MODEL 6P1 PORTABLE RADIO RECEIVER

IMPORTANT SERVICE INSTRUCTION

INSTRUCTIONS FOR REPLACING RECTIFIER ASSEMBLY

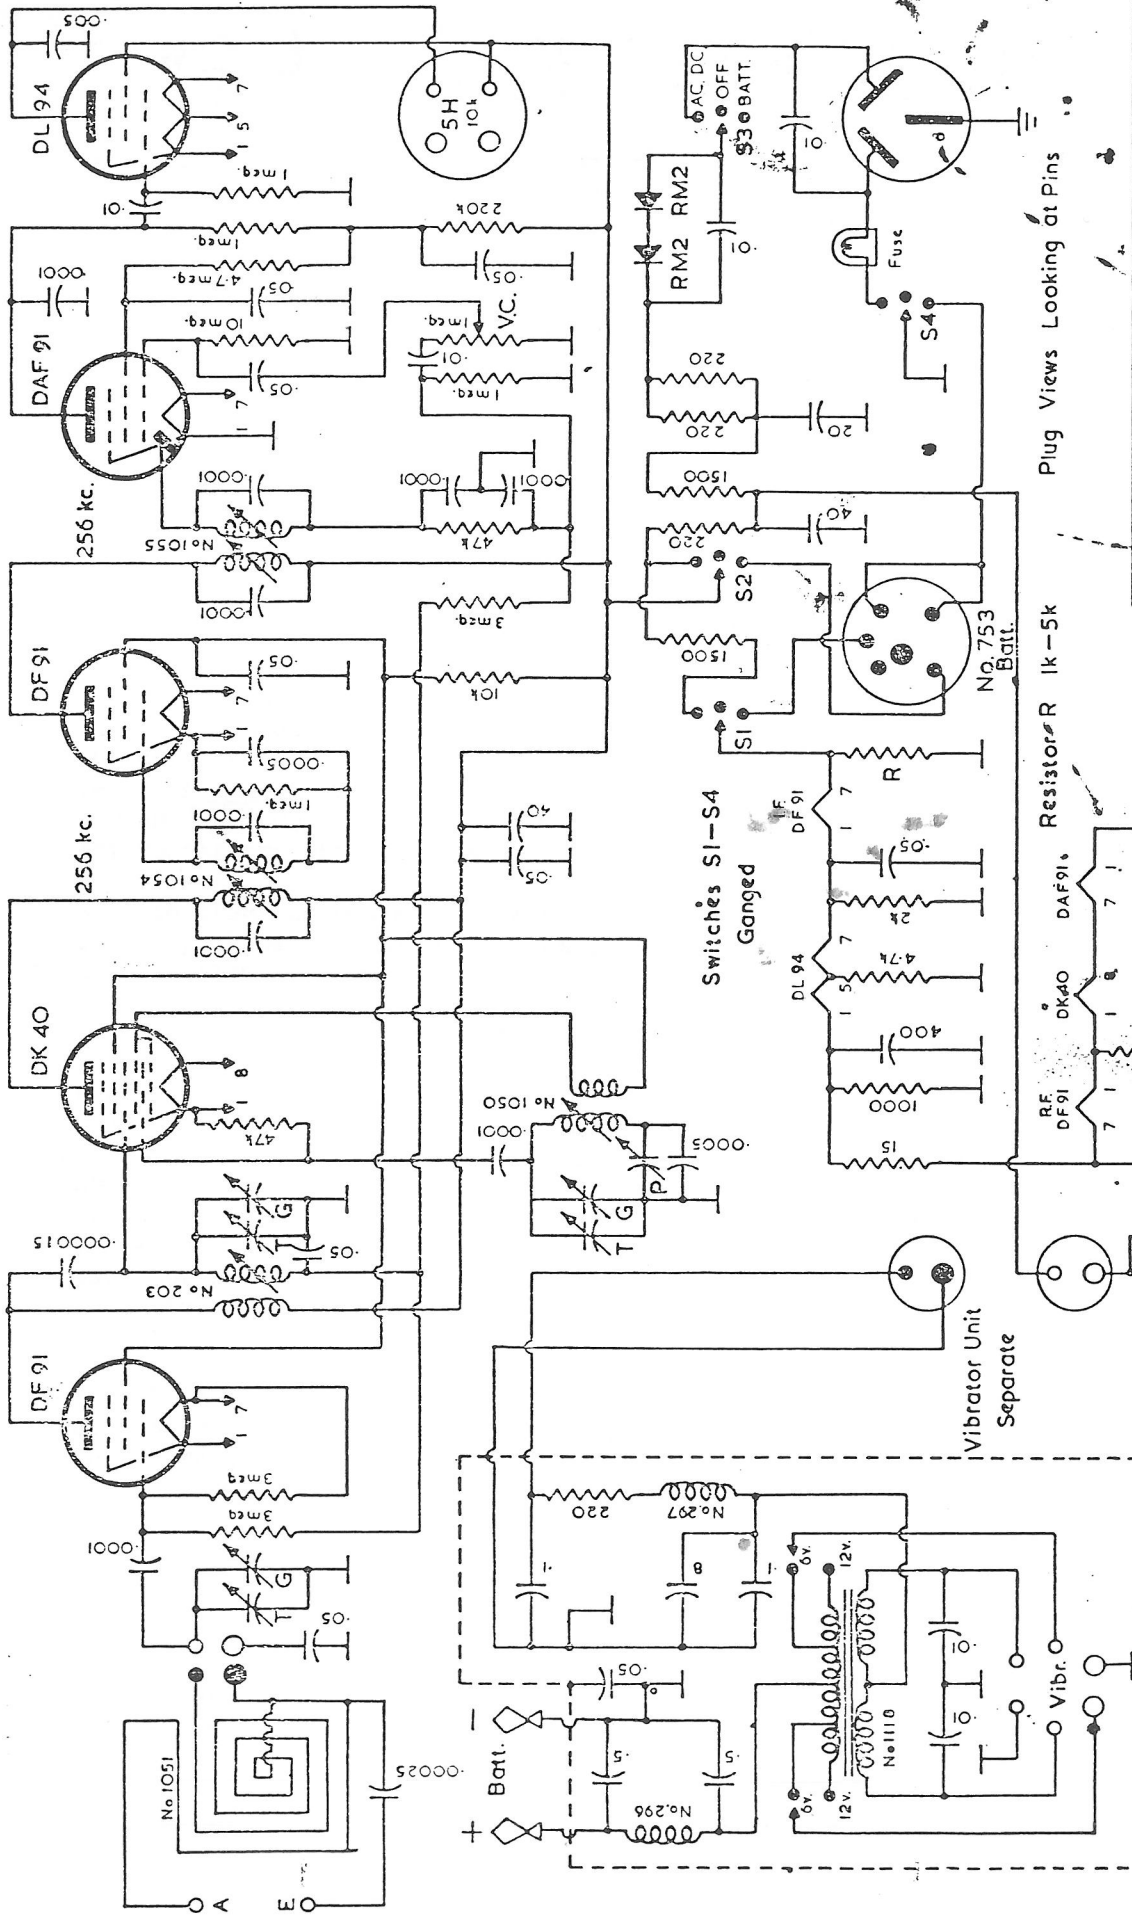
5. Having mounted the bracket reassemble the new rectifier stack on the bracket with the bracket between the two rectifiers and with the condenser pointing to the rear of the cabinet.

6. Connect the free end of the series parallel arrangement of 4 only 220 Ohm 1 watt carbon resistors to the end of the wire-wound resistor from which the two carbon resistors in parallel were originally detached when removing the defective rectifier stack.

IMPORTANT: Please note that the positive end of the rectifier stack must go to the side nearest to the wire wound resistor to which it must be connected through the series parallel carbon resistors, the total resistance of which will be 220 ohms.

7. Lengthen the lead to be soldered to the negative end of the ~~resistor~~ ^{rectifier} stack by approx. 1" and connect.
